Historical Architectural Review Board
COA Preliminary Review Sheet

HDC-2025-00033

Address: 806 Monroe Street

Proposal: Infill door opening and re-stucco first floor and side.

Monroe Street Elevation, April 2025 (City of Allentown)

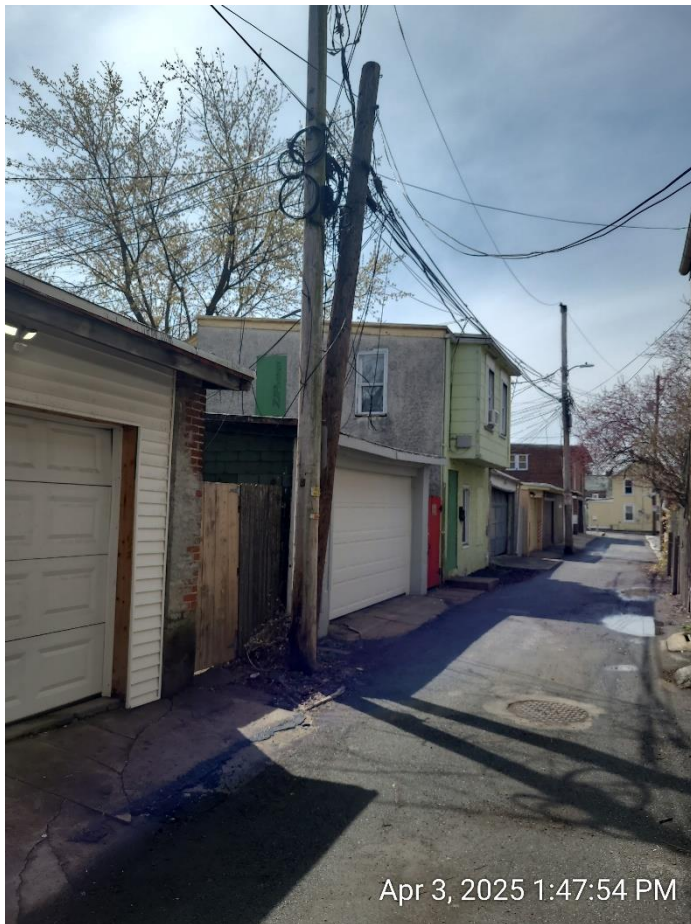
5/5/25 Observations & Comments: Infilling a doorway on a primary façade is not appropriate, as entry doors contribute to the composition of the primary façade. Removing a point of building egress may require approval by the Bureau of Building Standards and Safety, separate from HARB review. More information would be helpful to understand why door infill is the proposed solution; have other options been explored to maintain a secure entry?

Maintaining the stucco on the exterior walls of the building is appropriate; based on available imagery, the stucco has been in place since before 2008.

The application states the possibility of installing shutters along the Monroe Street elevation. More information would be required to review this item, such as evidence that shutters historically existed on the building. Refer to Guideline 3.5.21.

1. If removal of the front door is acceptable to the HARB, the proposed exterior finish to match the adjacent stucco is appropriate.
2. Maintaining the existing first floor window that was previously covered over is appropriate. All visible windows appear to be vinyl replacement windows. While new vinyl windows are not appropriate per the Guidelines, 3.5.12 states “If replacing a single window on a façade, replicate the existing windows of that façade.”
3. The proposed mailbox is a simple design and is appropriate.
4. Per the Guidelines, shutters should not be added where there is no evidence they existed historically. Vinyl shutters are not appropriate.

If removal of the front door is acceptable, staff recommend approval with the following conditions:

- Stucco over door infill is installed as presented.
- Mailboxes are installed as presented.
- Shutters are not installed.

Proposed Door Infill Area (City of Allentown)

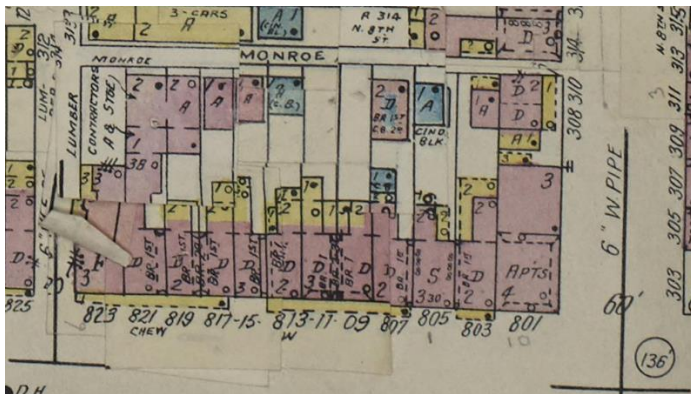
1. Door (facing Monroe St): The door was within a 30” opening and was removed and framed using a double 2x4 header and 3-2x4 studs. The opening was insulated and covered with ¾” ZIP plywood panel, and will be finished with mesh wire and stucco mortar to match existing finish of rest of property.

The applicant clarified that the right side first floor window was covered by plywood by a previous owner. The current window existed behind the plywood. The door along Monroe Street has been removed and infilled, and the stoop is currently remaining. The applicant noted that he would prefer to remove the stoop, if appropriate. While the applicant would like to install shutters, the HARB discussed that shutters can only be installed where they existed historically.

- Stucco over door infill is installed as presented.
- Mailboxes are installed as presented.
- Shutters are not installed.
- Stoop Monroe Street is removed.
